RE: ACKNOWLEDGEMENT OF RECEIPT OF ADDENDUM NO. 3

ADDENDUM NUMBER 03

PROJECT: **MIB RENOVATIONS**
REID STATE TECHNICALCOMMUNITY COLLEGE
GMC PROJECT NO. ABHM250047

H8 SUSPENDED GYP SOFFIT 1
SCALE: 11/2" = 1'-0"

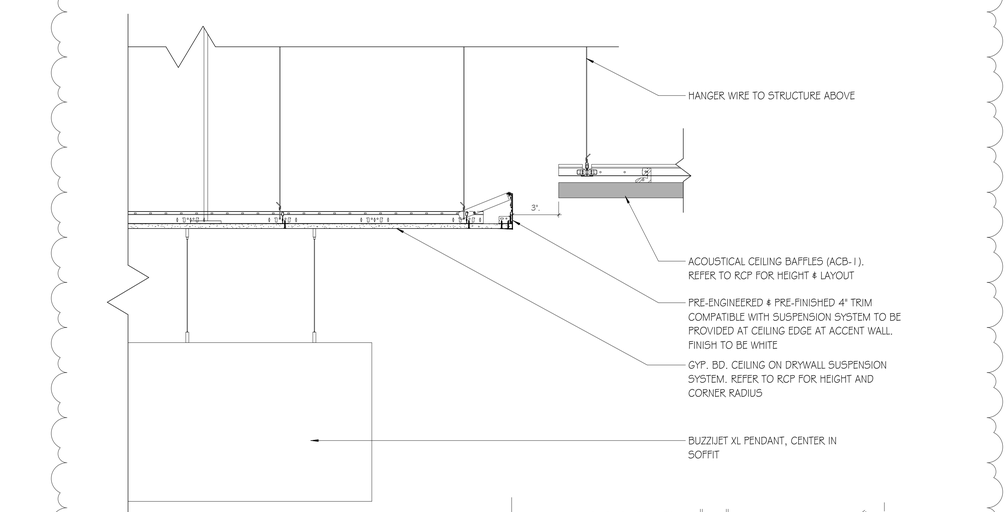
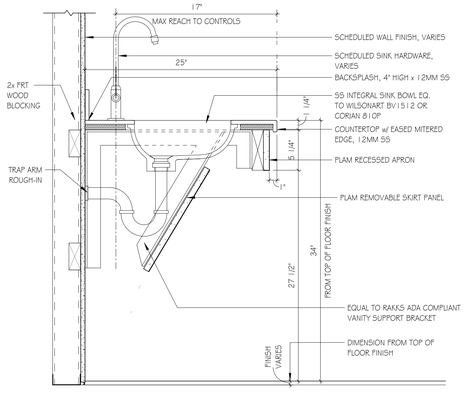
K. Reference Revised Sheet **A7.11 – INTERIOR DETAILS** and replace with attached revised sheet.
   i. Added section details for suspended gyp soffit in Entry 701.

A9.02

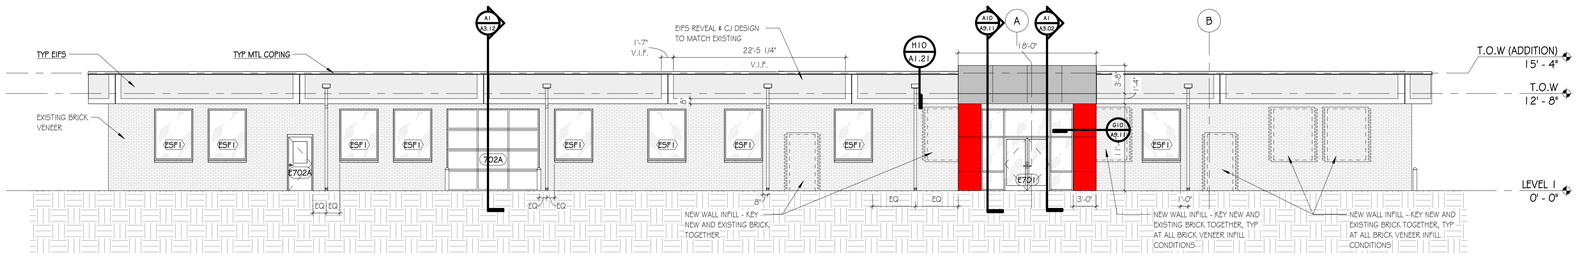
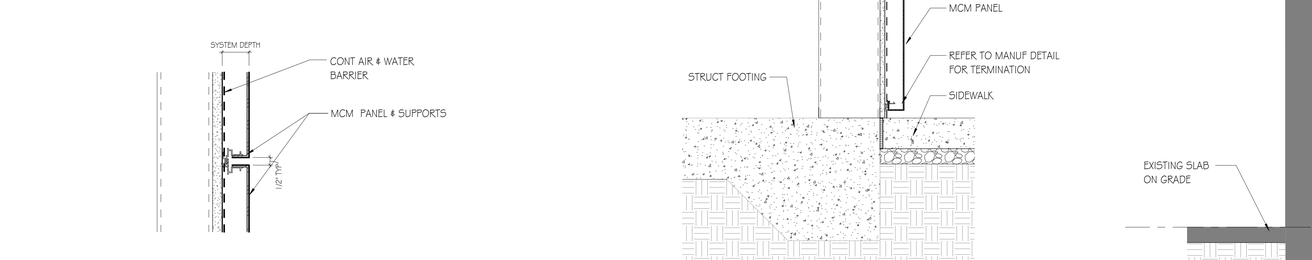
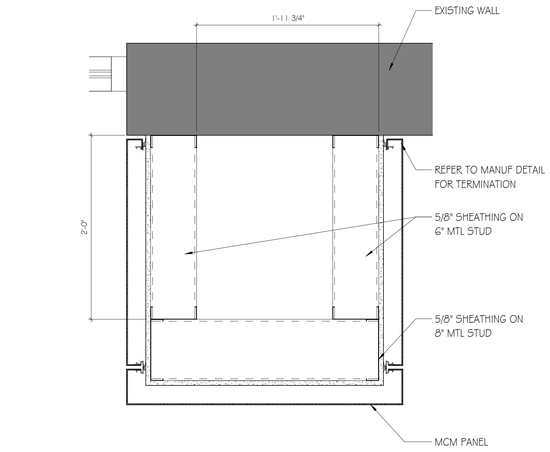
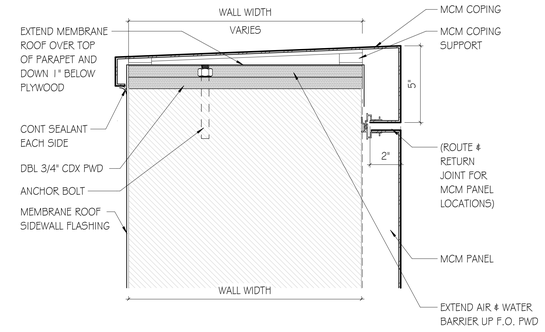
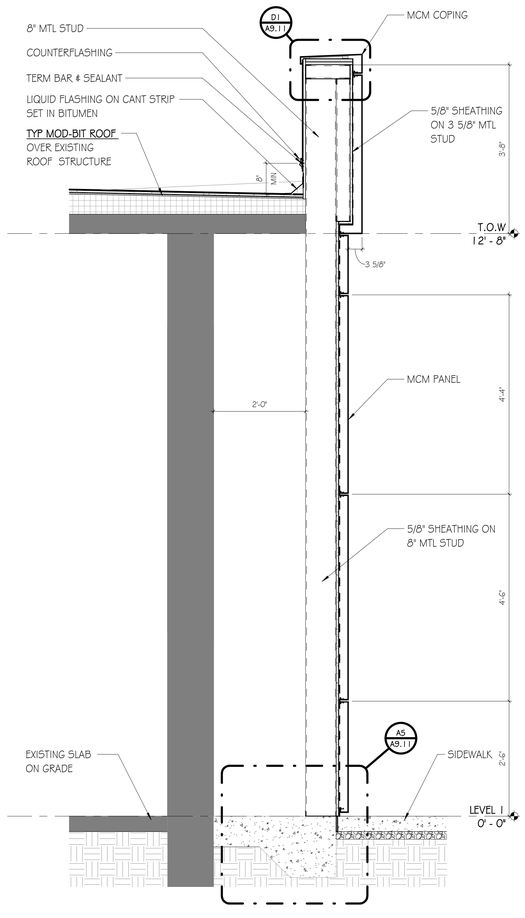
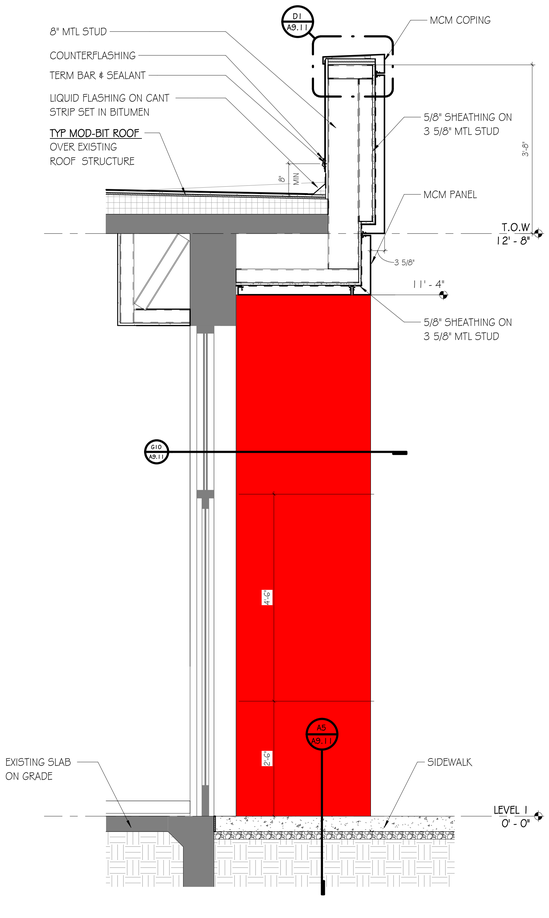
P. Reference NEW **Sheet A9.11 – MCM ENTIRES – ALTERNATE 1**.
   i. Add Alternate 1. MCM clad entries at each main entry of buildings 300 and 700. Extent of paneling defined per plan detail, section, and exterior elevation.

NEW OVERHEAD DOOR OPENING AT EXISTING MASONRY ELEVATION

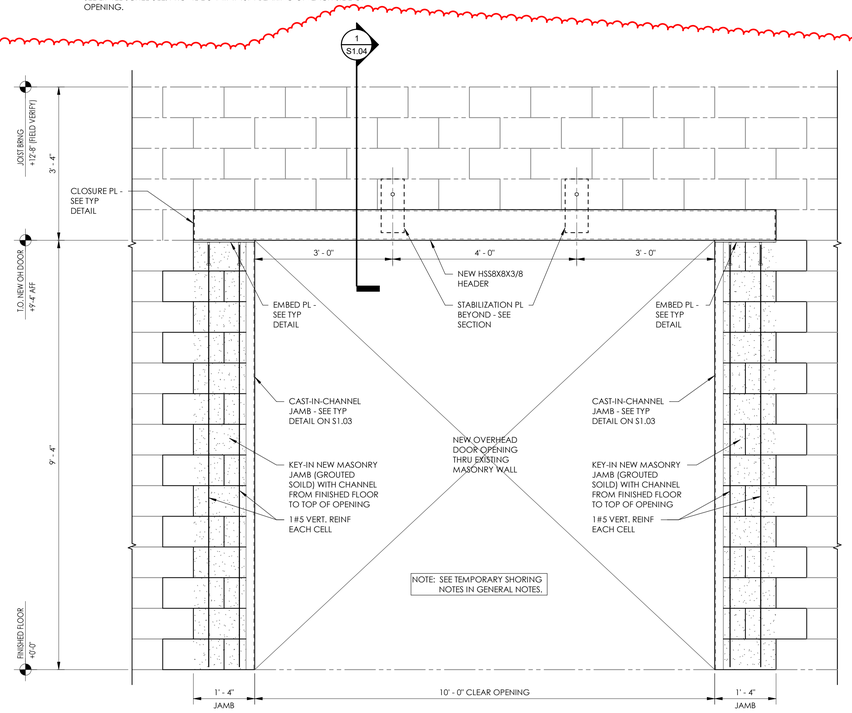
C. Reference Revised Sheet **S1.04 – TYPICAL DETAILS** and replace with attached revised sheet.
   i. Added "New Overhead Door Opening at Existing Masonry Elevation" And Details to Sheet. Updated Note In "Typical Beam Bearing at Bond Beam Detail" On Sheet.

1 BUILDING 300 HVAC Floor Plan
SCALE: 1/8" = 1'-0"

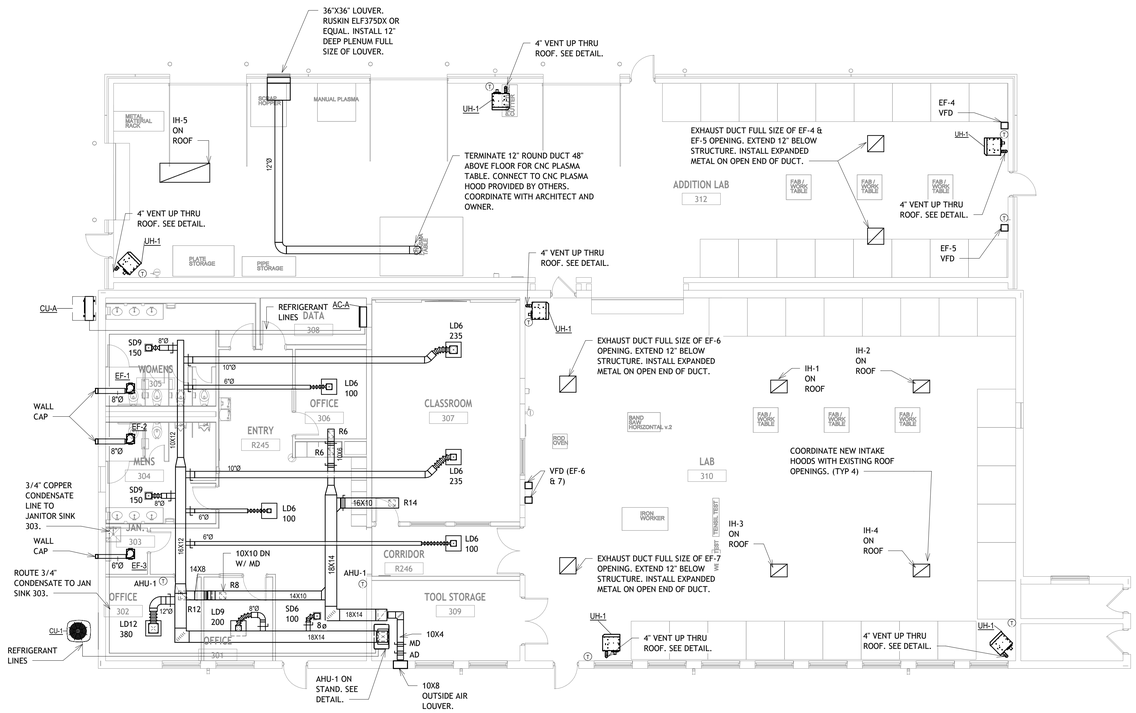
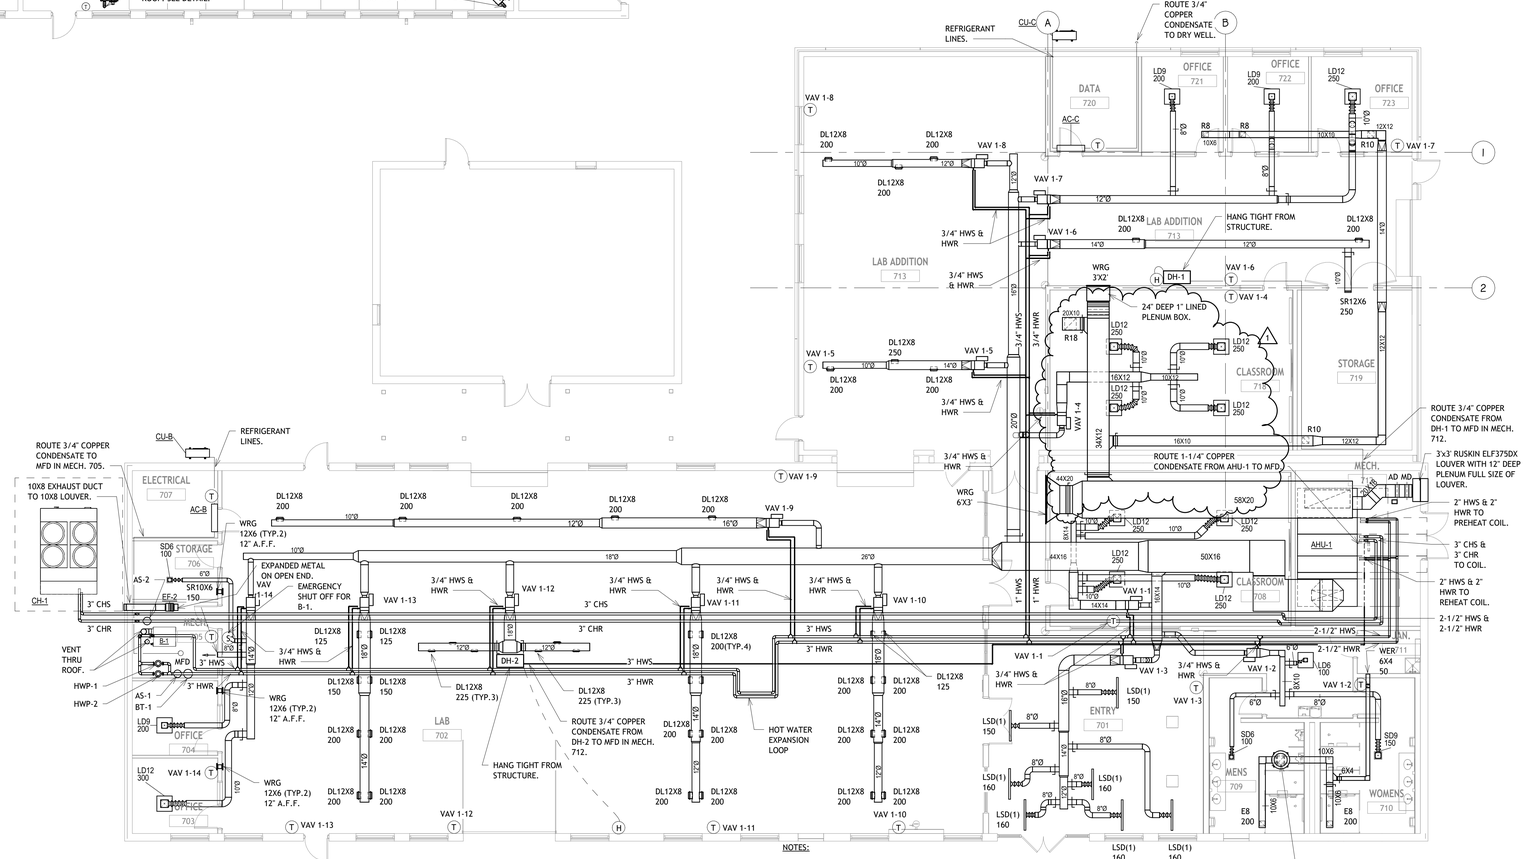
A. Reference Revised Sheet **M2.01 – HVAC NEW WORK FLOOR PLAN** and replace with attached revised sheet.
   i. Ductwork coordination with structural in classroom 708 and classroom 718.
